## INTRODUCTION

This report sets out Hillingdon Council's detailed response to the Government's consultation document "Adding Capacity at Heathrow Airport" published on 22 November 2007. In addition to this report, the Council's opposition to the principle of a third runway at Heathrow, as detailed in the White Paper titled "The Future of Air Transport" December 2003 is set out in its original response to the SERAS consultation (The Future Development of Air Transport in the United Kingdom: South East – a National Consultation (Second Edition February 2003)) which is available on the Council's website. It is considered that the Council's original submission and arguments against the third runway are equally applicable and therefore remain relevant. In almost every respect the impacts identified at the time of the White Paper have worsened when compared to the current consultation proposals.

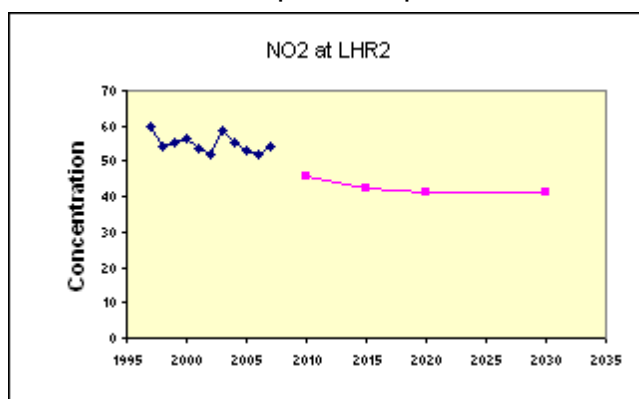
36. In Table 3.7 of the “Population Exposure to Air Pollution Report” - Atkins 2007, results are supplied for properties exposed to pollution levels above 40ug/m<sup>3</sup>. A request made by 2M, on behalf of their appointed consultants, to expand this table to show properties in the bands 38-38.9ug/m<sup>3</sup> and 39-39.9ug/m<sup>3</sup> resulted in the following information, reproduced below:

37. As can be seen the number of properties exposed to levels just below the 40ug/m<sup>3</sup> is significant. Also the number of properties in the 38ug/m<sup>3</sup> - 38.9ug/m<sup>3</sup> contour has remained relatively static from 2015-2030. The importance of this population so close to the EU limit is explained in the following section concerning model verification, uncertainties, sensitivities and trend analysis and is explored in depth in Appendix 2 Air Quality Review paragraph 4.47-4.50.
